Addendum to Statement by John Spain Associates

ASP- **314232-22**

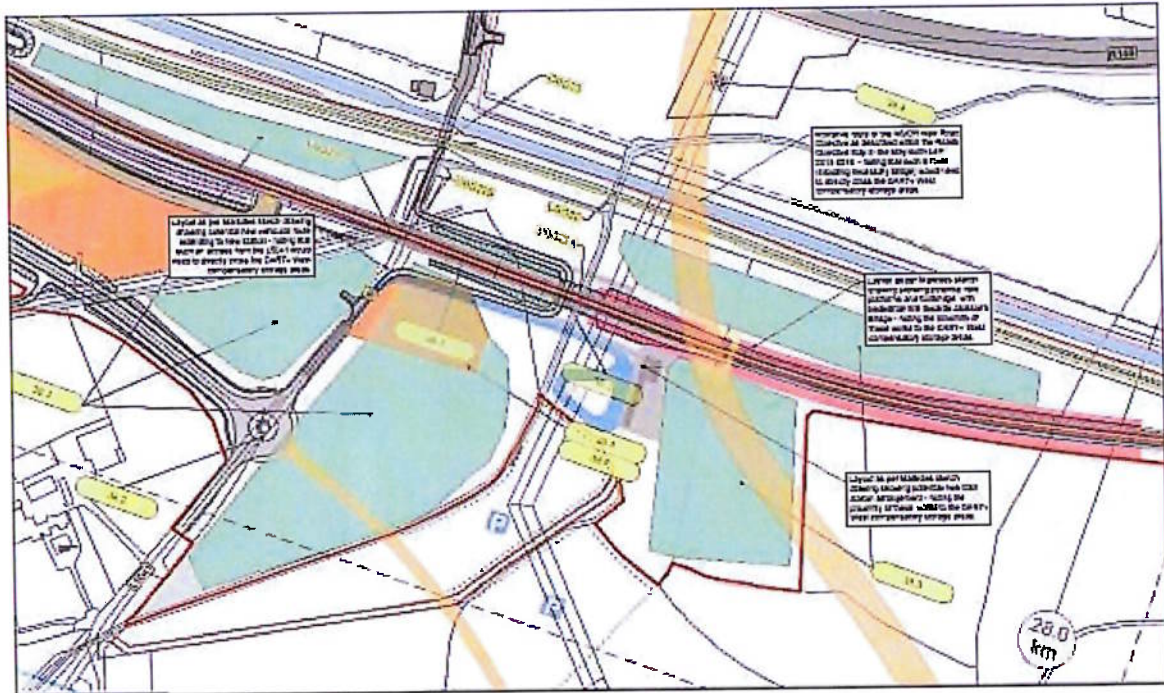
It is not disputed that the design of the MOOR will be required to take flood risk into account, however it is considered that the provision of DART+ West proposals will amend the flood regime in the area significantly. While the DART+ West design has considered existing flood conditions, in the case where DART+ proposals are granted the MOOR will need to consider both existing and new flood conditions – and specifically will need to consider the impact of altering the DART+ West compensatory storage areas.

As with the provision of the new train station and park & ride, the provision of the MOOR may be reliant on amending the DART+ West storage areas, and **if amending such storage areas to provide the MOOR becomes prohibitive to same, then it could be the case the DART+ West proposals could be seen as precluding the MOOR.**

It is therefore requested again that the Applicant demonstrate in detail how the works do not preclude the MOOR, not only from a geometrical perspective but also showing how their flood storage areas could be amended in future to enable such works.

An alternative design of the proposed flood storage areas should be prepared showing the MOOR route and bridge incorporated. This would need to demonstrate that the extent of such amendment works would not preclude the provision of the MOOR in this location.

To summarise, the flood storage areas required for the delivery of DART+ West are located in areas where statutory infrastructure is proposed. This is shown in the composite sketch drawing 230083-DBFL-RD-DR-C-0201 which combines the DART+ West works proposal, the previous sketch prepared by Markides, and the routing of the MOOR as per the Maynooth LAP 2013-2019. An extract of same is shown below.

- DART+ West relies on new flood storage areas
- The New Train Station, Park & Ride, and the MOOR have been identified as passing through / sited near these areas
- The new infrastructure may therefore need to amend storage areas
- If this is not possible, then DART+ West is precluding such infrastructure
- We request the applicant shows how all can be integrated both from geometry and flooding perspective
